# HVAC REVIEWED

SITE NAME: ROUNDEL HOMES INC  
BUILDER: GREENPARK HOMES

TYPE: GLENROWAN 3

Building Permit #: **BP#-22-00085**

BASEMENT FLOOR PLAN 3 BASEMENT FLOOR PLAN 2

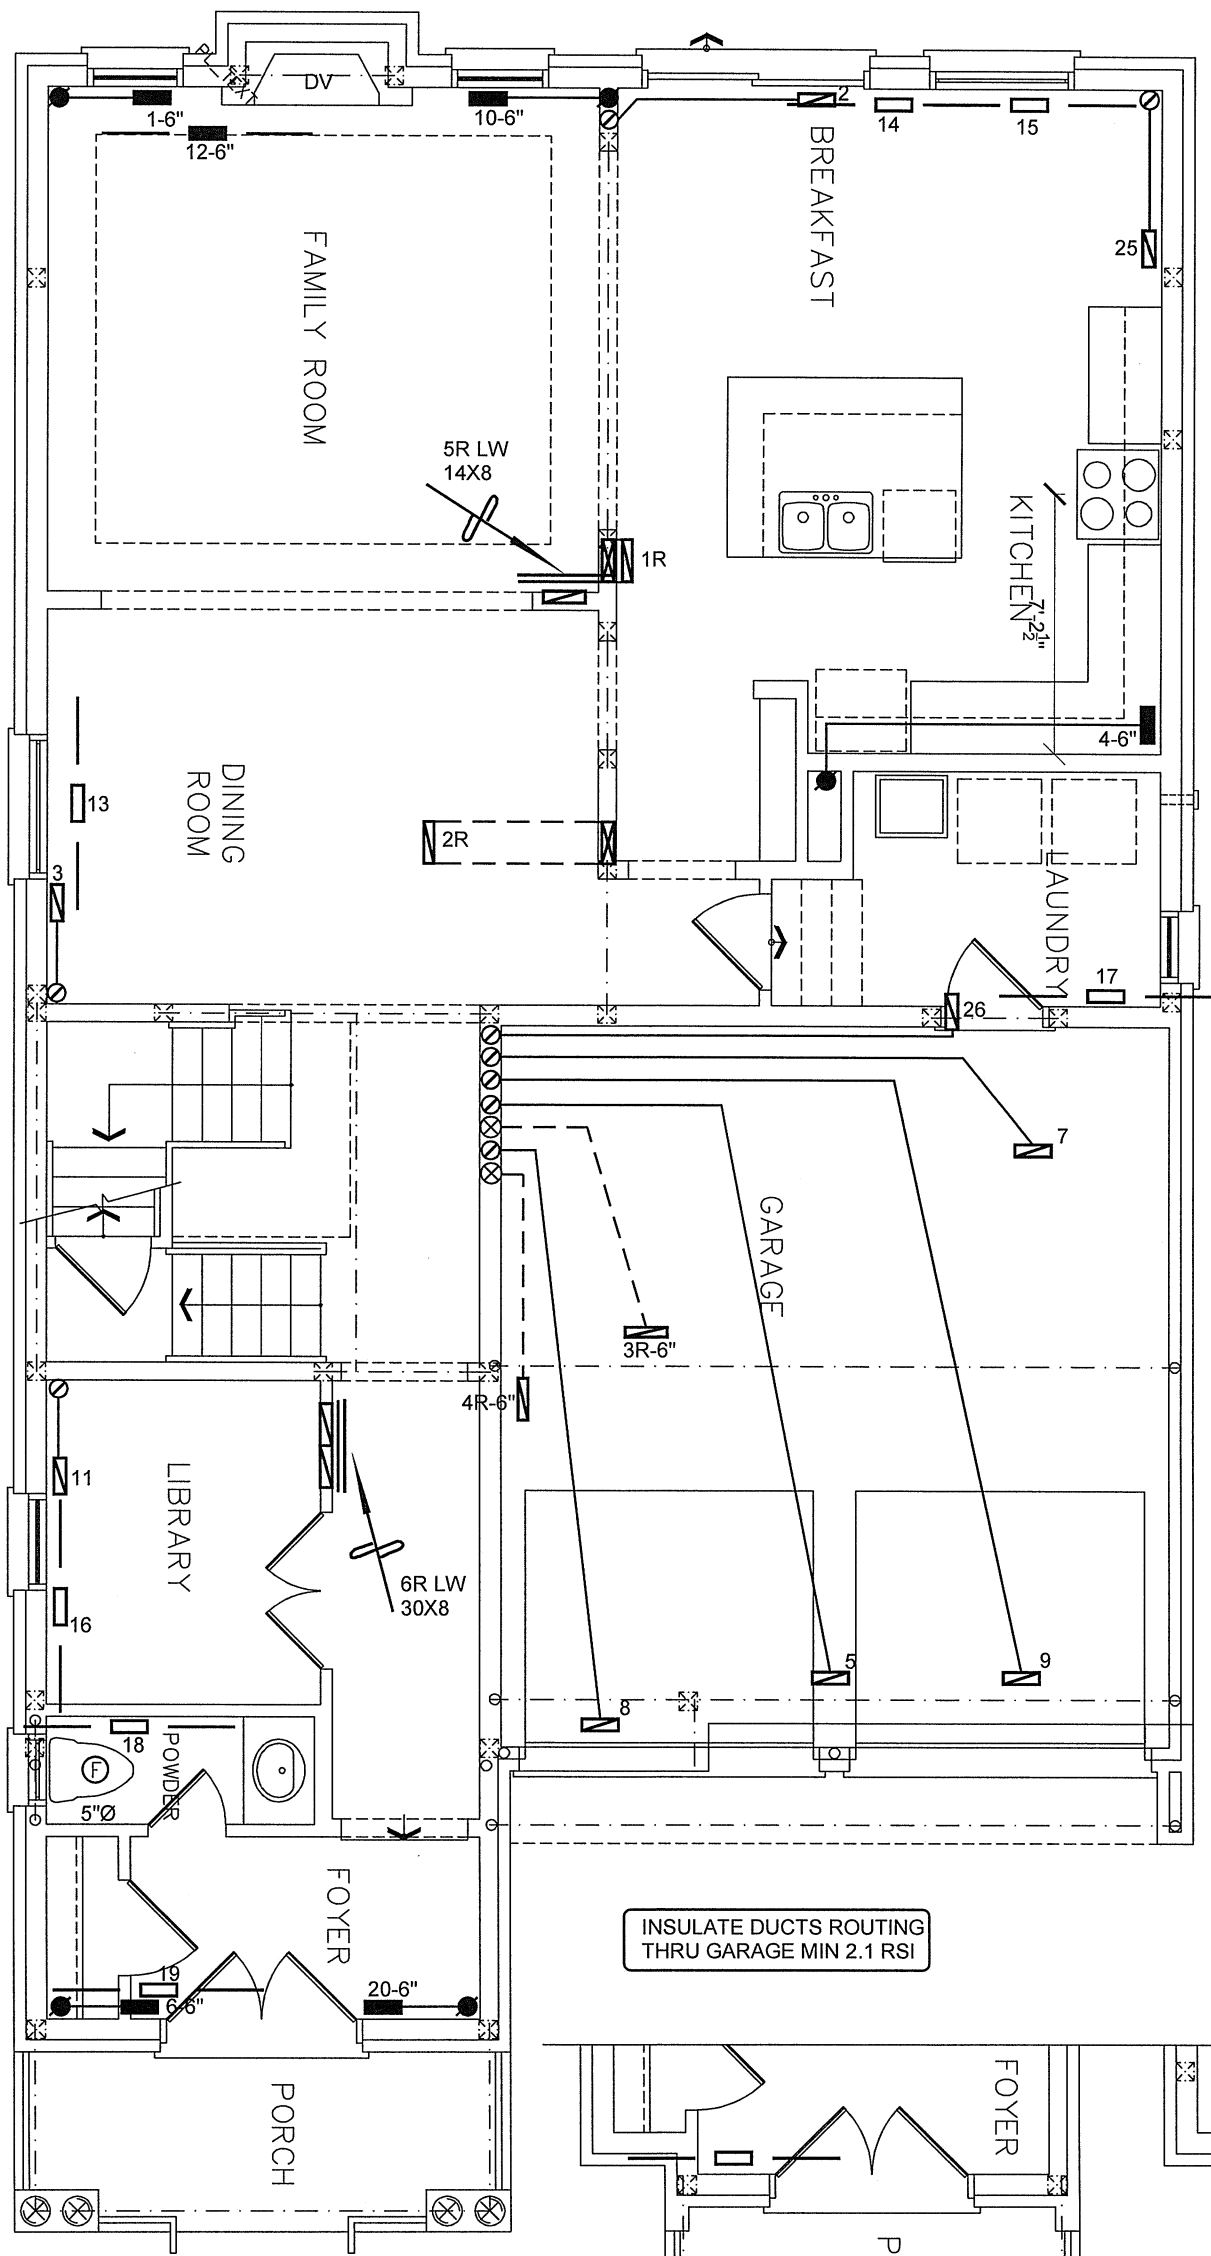
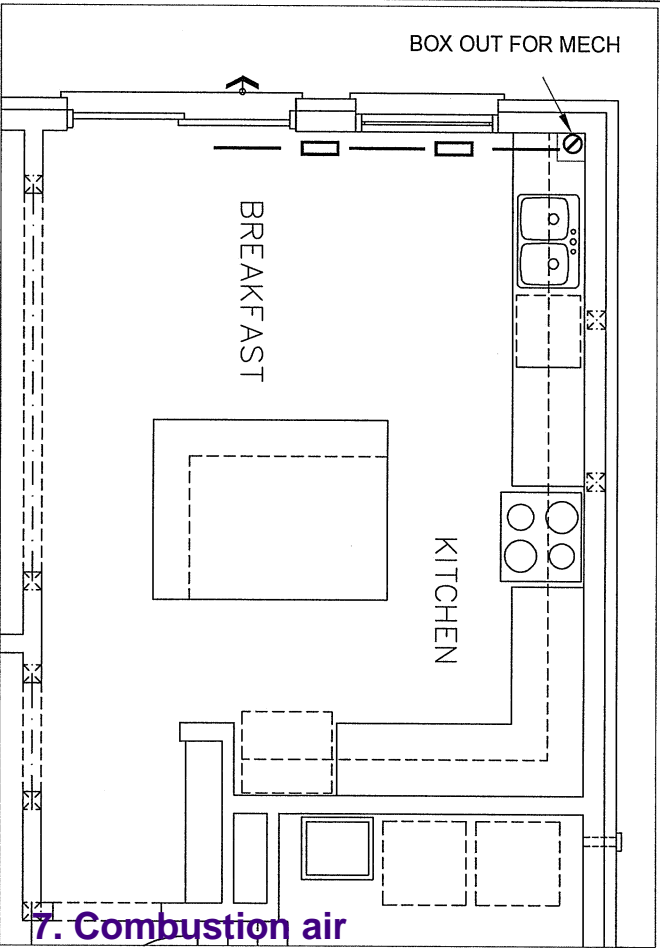
Ensure that R-Values and U-Values used for heat loss and heat gain calculations are consistent with the values specified by SB-12 Prescriptive Package A1 and the values used for architectural design.

1. Laundry dryer exhaust duct shall be provided as per OBC 2012 Div.B 6.2.3.8(7).
2. Kitchen hood exhaust duct shall be provided as per OBC 2012, Div.B 9.32.3.10, 9.32.3.5(2).
3. Minimum R-12 Insulation Value required for ducts installed at unheated or exposed condition (OBC 2012 Div.B 6.2.4.3(10) and seal the ducts as per 6.2.4.3(11) & HRAI Digest 2005, Clause 4.5.
4. Penetration of Air Barrier System by ducts, wires, conduits or building materials shall be sealed as per OBC 2012, Div.B 9.25.3.3.(9) & (10).
5. Volume control dampers to all branches to be installed per OBC 2012, Div.B, 6.2.4.5.
6. Space between studs and joists used as return ducts shall be separated from unused portion as per OBC 2012 Div.B 6.2.4.7(6)
